IMPORTANT SAFETY RECALL NOTICE

Subject: **Motor Vehicle Safety Recall 13V-485**
Sure Power 80 Amp Equalizer PN 52208 (New Flyer PN 204012)

ITS: 5557	
SECTION:	260 Battery Compartment
WRITTEN BY:	Ken Chubaty
SUBJECT:	Replace Sure Power Equalizer

Figure 4: Old Equalizer (Left) and New Equalizer (Right)

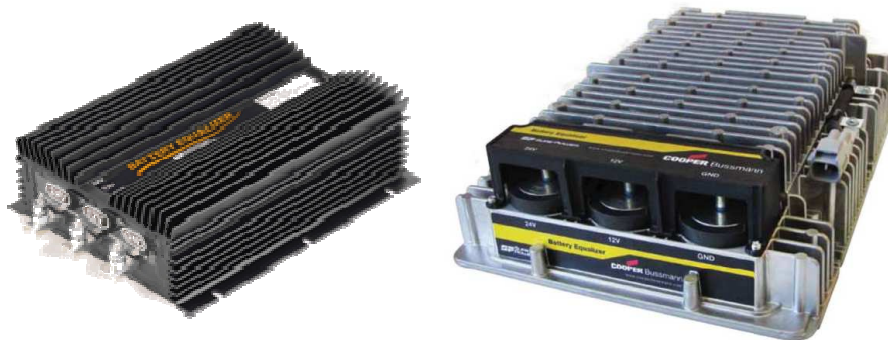
New Flyer stopped installing PN 52208 in 2007. Since that time a replacement equalizer has become commercial available (Sure Power PN 21080 EOO). New Flyer and Sure Power propose to replace all the existing PN 52208 equalizers installed on New Flyer buses with the PN 21080 equalizers.

7. Using the new equalizer (NF PN 6405754), mount it to the mounting bracket with the hardware that was previously used.
